## DSP-15016

Application	General Data	
<b>Project Name:</b> Blue, Parcels 61 and 130  <b>Location:</b> On the western side of Baltimore Avenue (US 1) approximately, 115 feet south of its intersection with Jefferson Street at 5334 Baltimore Avenue, Hyattsville  <b>Applicant/Address:</b> Hyattsville Route One Partners, LLC 6110 Executive Boulevard, Suite 430 Rockville, MD 20852	Planning Board Hearing Date:	10/06/16
	Staff Report Date:	09/26/16
	Date Accepted:	05/06/16
	Planning Board Action Limit:	Waived
	Plan Acreage:	0.56
	Zone:	C-S-C/D-D-O
	Dwelling Units:	16
	Gross Floor Area:	N/A
	Planning Area:	68
	Council District:	02
	Election District	16
	Municipality:	Hyattsville
	200-Scale Base Map:	206NE04

Purpose of Application	Notice Dates	
Approval of a 16-townhouse development	Informational Mailing:	06/23/15
	Acceptance Mailing:	05/05/16
	Sign Posting Deadline:	09/06/16

SUBJECT: Detailed Site Plan DSP-15016, Blue  
Parcels 61 and 130

# SITE PLAN

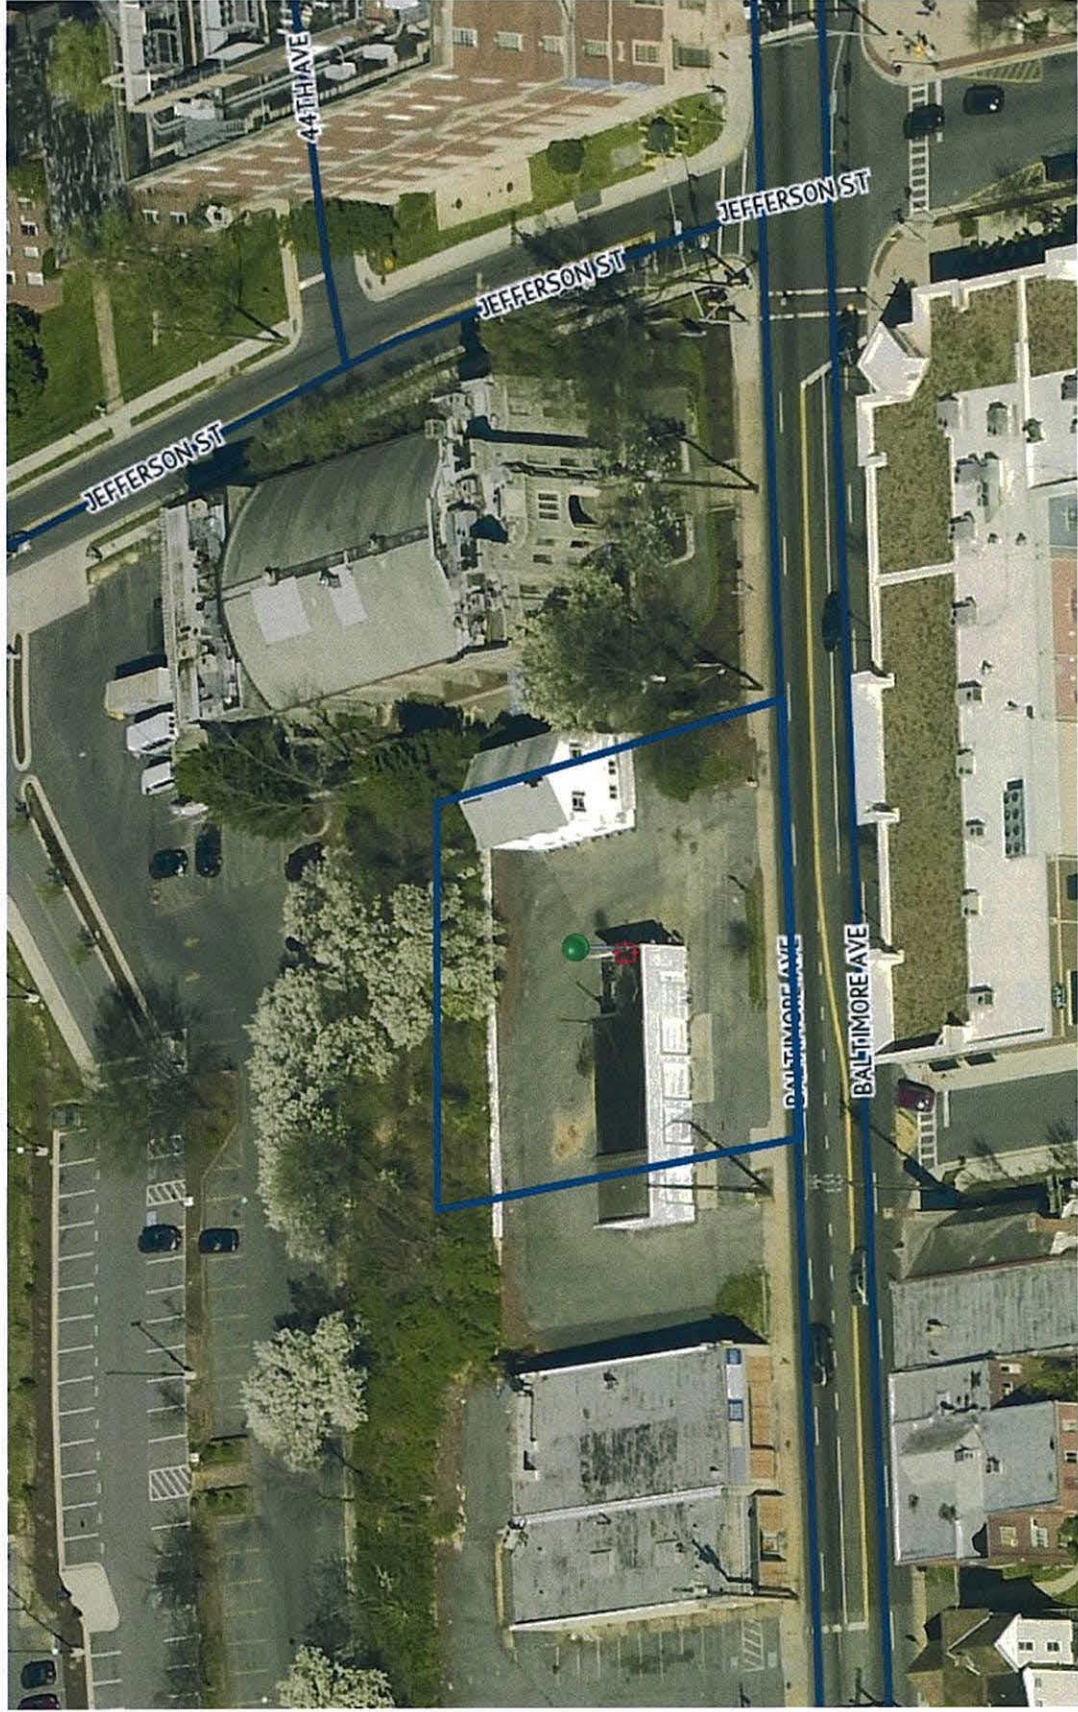
The architecture for the longest and third stick of townhouses (Units 8–16) is similar to the front two. A major difference is that these units provide garage-access from the front and that, due to the grade, the units are three stories tall in the rear and are four stories in the front. The garages doors are single, paneled, and have two windows in the upper portion of each door. A covered entranceway is provided for every other unit. Two of the seven units have decks on the second floor of the front façade, accessed by a single door and all units have decks on the fourth story. All decks are accessed via glass sliding doors. Another difference in the architecture of this stick is that brick is included on the second story of all units except for Unit No. 8. Staff believes it is an error. A proposed condition, in the Recommendation section of this report would correct this drafting/design error.

Though lighting for the units is indicated on the building elevations, for all front, rear and deck and garage doors, a detail is not provided. A proposed condition, in the Recommendation section of this report, would require that such detail be added to the plans, prior to certificate approval. Street lighting is to be provided by the inclusion of three “acorn streetlights” on the plan. One is provided on the northern side of the access drive, one at the northern terminus of the private road and still another one at the southern terminus of the private road. A detail of the “Acorn streetlight” is provided on Sheet 4.

Staff notes that the mechanical equipment is visible on the roof of the buildings. As the Urban Design Section is concerned that the mechanicals may be visible from the street, a proposed condition in the Recommendation section of this report would require that the applicant provide line of sight drawings demonstrating that the mechanicals from the street or, if they are to be visible, that the applicant revise the architecture for the project, prior to certificate approval, to include a parapet along the roofline that would completely screen the mechanical equipment.

An aluminum fence and a vinyl fence are proposed for the development. The aluminum fence would be utilized to prevent pedestrian traffic from Baltimore Avenue (US 1) on the southern side of Unit 7 and along the western portion of the southern boundary of the project. A vinyl fence is specified for the western boundary of the site, but an elevation detail for the fence was

not provided on the detail sheet. As vinyl does not wear well, and as the color is unspecified, staff would recommend, and a proposed condition in the Recommendation section of this report would require, that the applicant provide a fence detail, indicating that a composite material be utilized for the privacy fence, with final design approval of the fence by the Urban Design Section as designee of the Planning Board. Note that the proposed six-foot-high fence requires a deviation from development district standards. See Finding 7 for a more detailed discussion of that deviation.

1. Prior to the certificate approval, the plans shall be revised as follows and the specified additional materials submitted:
  - a. A limited right-in/right-out access to Baltimore Avenue (US 1) with raised channelization designed to meet Maryland State Highway Administration (SHA) standards shall be indicated on the plan so as to prevent any left-hand turn movements, unless modified by SHA.
  - b. The proposed north-south private road, and the sidewalk along it, shall be extended to the southern property line.
  - c. Bottom-of-wall elevations shall be added to the retaining wall indicated on the site plan.
  - d. The vinyl specified for the privacy fence shall be replaced by a more durable composite material and an elevation drawing of the proposed six-foot-tall privacy

fence shall be included on the plans. The fence shall be approved by the Urban Design Section as designee of the Planning Board.

- l. A detail of the wall mounted light fixtures shall be included on the detail sheet and approved by the Urban Design Section as designee of the Planning Board.
- m. The architectural elevations for the project shall be revised to identify brick as the architectural material to be utilized on the second story of Unit 8.
- n. The public pedestrian and vehicular-access easements approved in Preliminary Plan of Subdivision 4-15016 shall be added to the DSP.
